**HILLSBOROUGH COUNTY
SOUTHEAST COUNTY LANDFILL
CAPACITY EXPANSION, SECTION 8
CERTIFICATION OF CONSTRUCTION
COMPLETION REPORT
RESPONSE TO DEP REQUEST FOR
ADDITIONAL INFORMATION**

Subject: Response to Request for Additional Information
Southeast County Landfill, Hillsborough County
Capacity Expansion Section 8
Certification of Construction Completion
Permit No. 35453-009-SC
Jones Edmunds Project No. 08449-020-01

**HILLSBOROUGH COUNTY
SOUTHEAST COUNTY LANDFILL
CAPACITY EXPANSION, SECTION 8 CLASS I LANDFILL
CERTIFICATION OF CONSTRUCTION COMPLETION REPORT
RESPONSE TO DEP RAI**

LTR.	DATE	REVISIONS	BY	APPRD.
1	2/28/06	SCS REVISIONS - NORTH SWALE MODIFIED		
2	2/28/06	EAST COLLECTION TRENCH DETAIL ADDED;		
		ADDITIONAL ROCK PLACED OVER PIPES;	JHV	JHO
		8x8 WYE ADDED; GEOCOMPOSITE ADDED

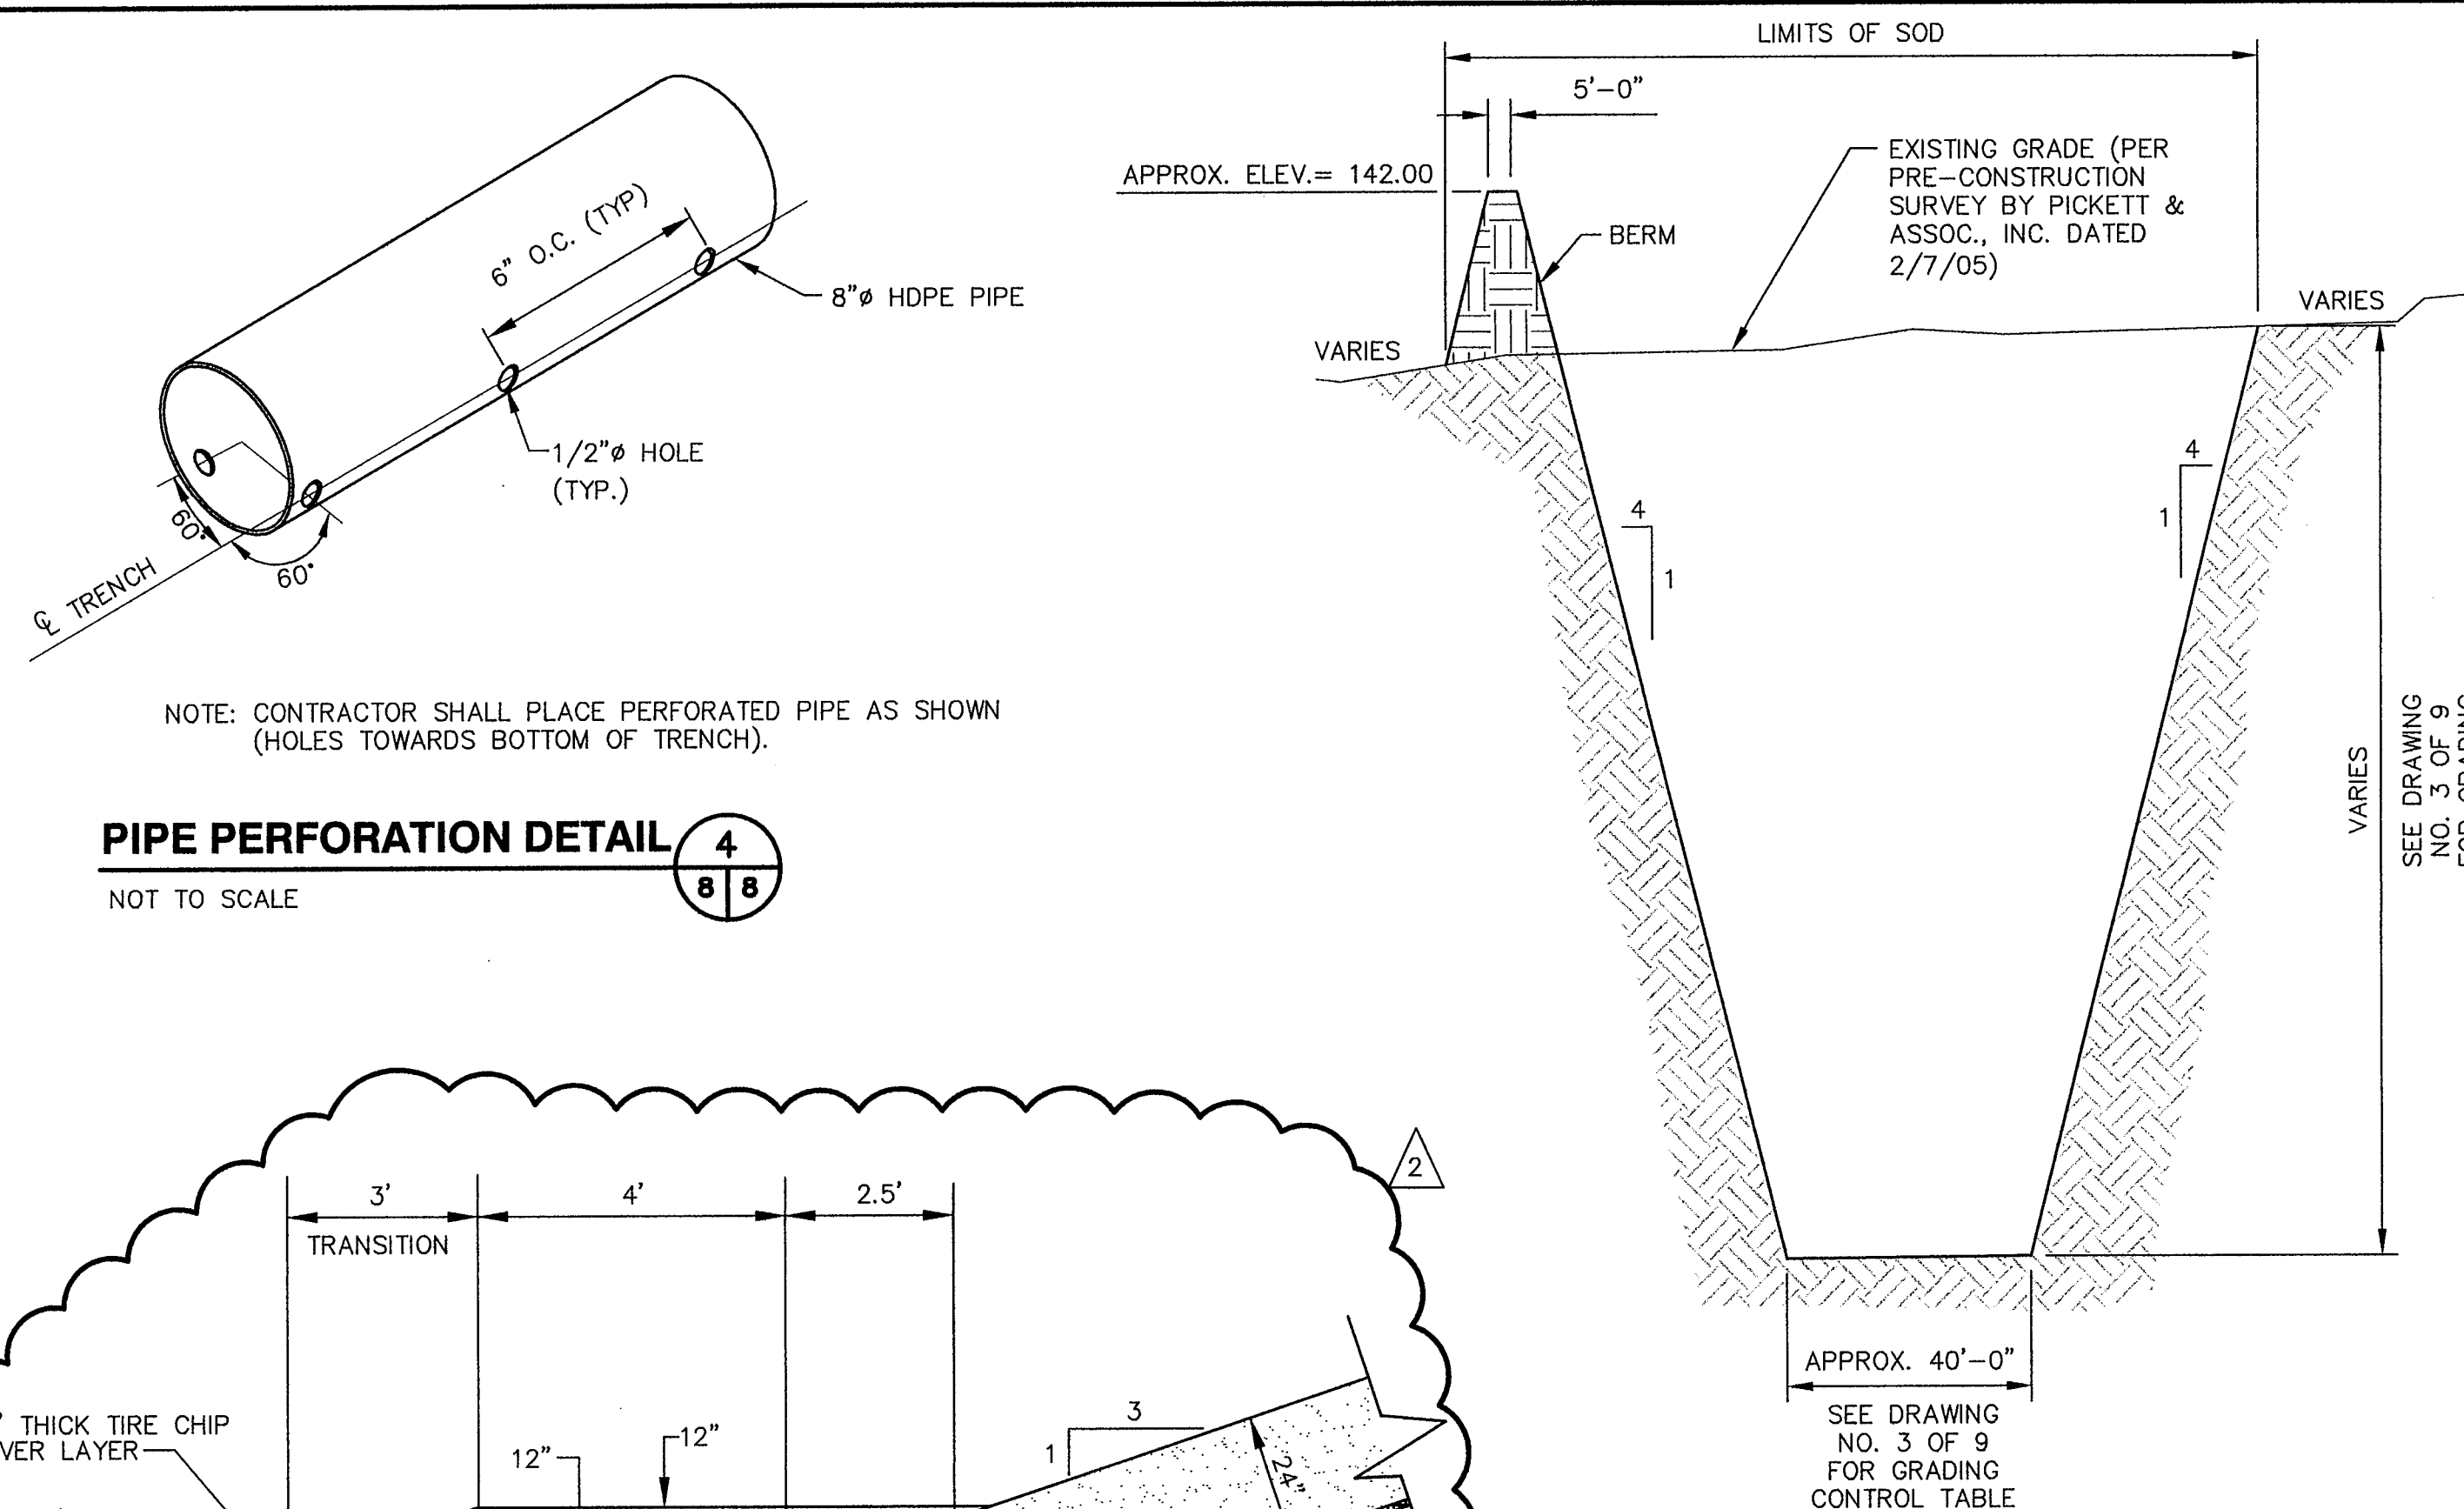
Comment 23: Sheet 5. Please specify the changes in Details 5/8 and 6/8.

Comment 26: Sheet 8. Please verify the detail number for the separation berm detail. It appears that there are two Detail 6 on this sheet.

Response 23: Detail 5/8 provides for the gravel pack around the eastern-most leachate collection, at the toe of the east side slope. The previous design for the gravel pack around the leachate collection pipe did not account for the pipe to be located near the toe of slope. The intent of the design was not altered.

Detail 6/8 provides for a slight change in the configuration of the reducer and wye to account for existing conditions. The intent of the design was not altered.

Response 26: There are two Details 6 on this sheet. Revised sheets 5 and 8 with the corrected detail references are provided in Attachment R26.
